# Supporting information for D1.1 comments\* on chromatic dispersion specifications

John Johnson, Broadcom

\* Reference D1.1 comments #18-29.

## 1. Sellmeier function over entire wavelength range

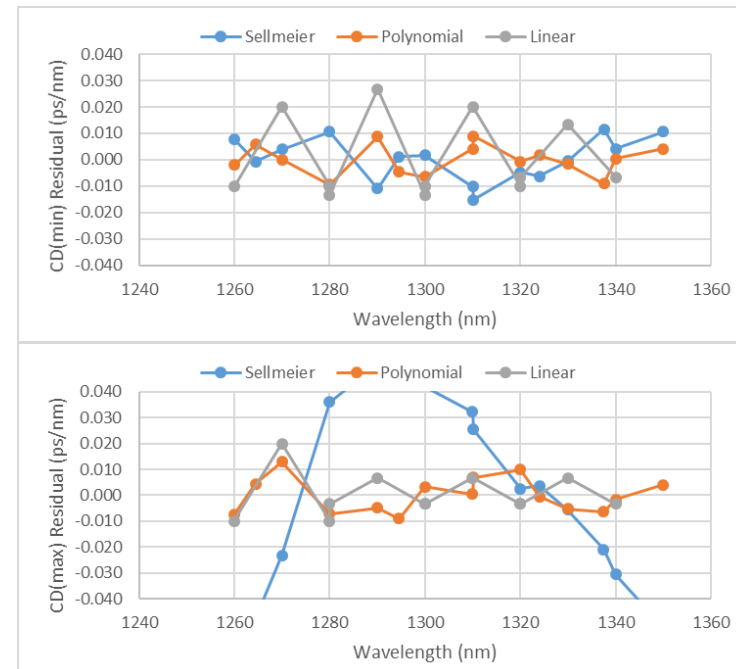
- Three possible empirical fitting methods for TX compliance were performed using G.652 data with  $M=1$ , at  $Q=99\%$  for the lower limit and  $Q=99.9\%$  for the upper limit for FR4.

- Well-known form used previously with worst case  $S_0$  and ZDW values
- Sellmeier coefficients are provided in G.652 for  $M \geq 4$ , but not for  $M=1$  due to irregular CD distributions, as previously proposed in Rodes\_3dj\_01a\_2407 for LR4
- Sellmeier fits for FR4 data using Excel Solver:
  - Min:  $0.1792 \cdot WL \cdot [1 - (1323.14/WL)^4]$
  - Max:  $0.1780 \cdot WL \cdot [1 - (1302.45/WL)^4]$

- The residual errors of the fits to the tabulated data points are compared below.
- The Sellmeier fit for  $CD(\max)$  is poor due to irregular distributions for  $M = 1$  with  $Q = 99.9\%$ .
- The polynomial and linear fits both give low residual errors that are  $< \pm 0.03$  ps/nm across the band.
- Propose using linear fits per channel for FR4, and Sellmeier fits for LR4
